**OFFICE OF CLIMATE
CHANGE, LICENSING
& RESOURCE USE**

INSPECTORS REPORT ON A LICENCE APPLICATION

To:	Directors	
From:	Dr Jonathan Derham	- LICENSING UNIT
Date:	21 JUNE 2007	
RE:	APPLICATION FOR A WASTE LICENCE FROM DUBLIN CITY COUNCIL, CIVIC OFFICES, WOOD QUAY, DUBLIN - LICENCE REGISTER W0232-01

Figure 5: Comparison of predicted ground level concentrations from **Maximum** process emissions and background levels, relative to ambient standards

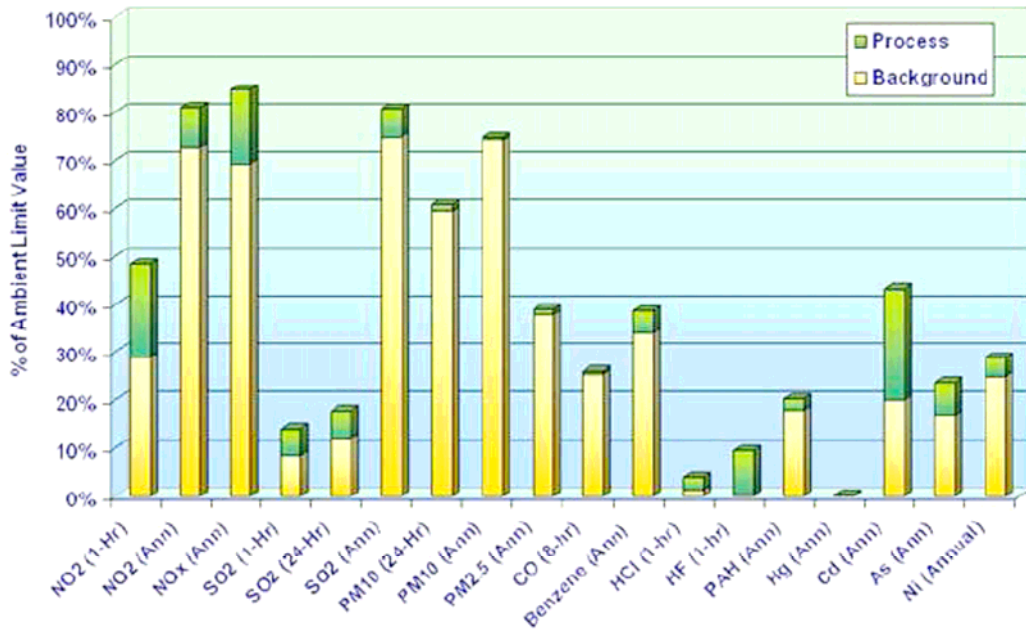
Modelling results for stack emissions demonstrates that predicted ground level concentrations are below the relevant air quality standards for the protection of human health for all compounds under typical, maximum and abnormal operation of the facility (refer Figures 5 & 6), and that maximum ground level concentrations all occur within 1km of the site. Modelling of PCDD/F emissions for the Maximum At Risk Individual (MARI) and Typical At Risk Individual (TARI) (being a typical urban dweller) demonstrates that for normal operation and accident scenarios the PCDD/F uptake is insignificant when compared to EU guideline values for PCDD/F Tolerable Weekly Intake. The modelling also predicts that under typical conditions ambient levels of PCDD/F will increase by just 2% (above existing background) at the nearest sensitive receptor (PCDD/F emissions under maximum operations at the nearest receptor predicted to be 0.7fg/m³ relative to an existing background of 42 - 44fg/m³).
